INDIANA DEPARTMENT OF TRANSPORTATION

STANDARDS COMMITTEE MEETING AGENDA

RE: Agenda for the July 20, 2006 Standards Committee Meeting

INDIANA DEPARTMENT OF TRANSPORTATION	TEMPORARY CHECK DAM, REVETMENT RIPRAP MARCH 2003	STANDARD DRAWING NO. E 206-TECD-01		1/1/ Richard L. Vorhees DESIGN STANDARDS ENGINEER DATE 3-01-03
				1/1/ Richard K. Smutzer CHIEF HIGHWAY ENGINEER DATE 3-01-03

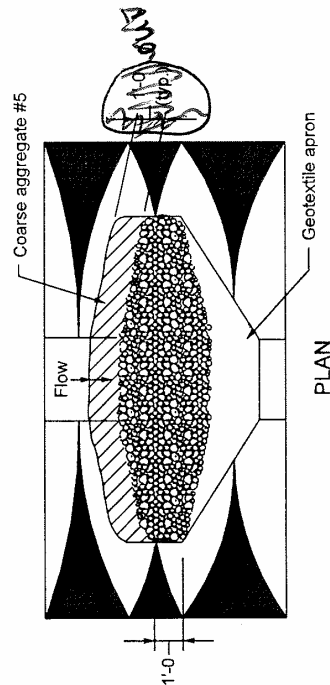
Item 14-4 Standard Drawing	Mr. Wright 205-TECD-01	7/20/06	28
Item 14-5 411	Mr. Andrews <i>WARRANTED MICRO-SURFACING</i>	7/20/06 400-53	31
Item 14-6 Revise Title From To	Mr. Heustis Contract Services Section <i>Contract Administration</i>	7/20/06	42
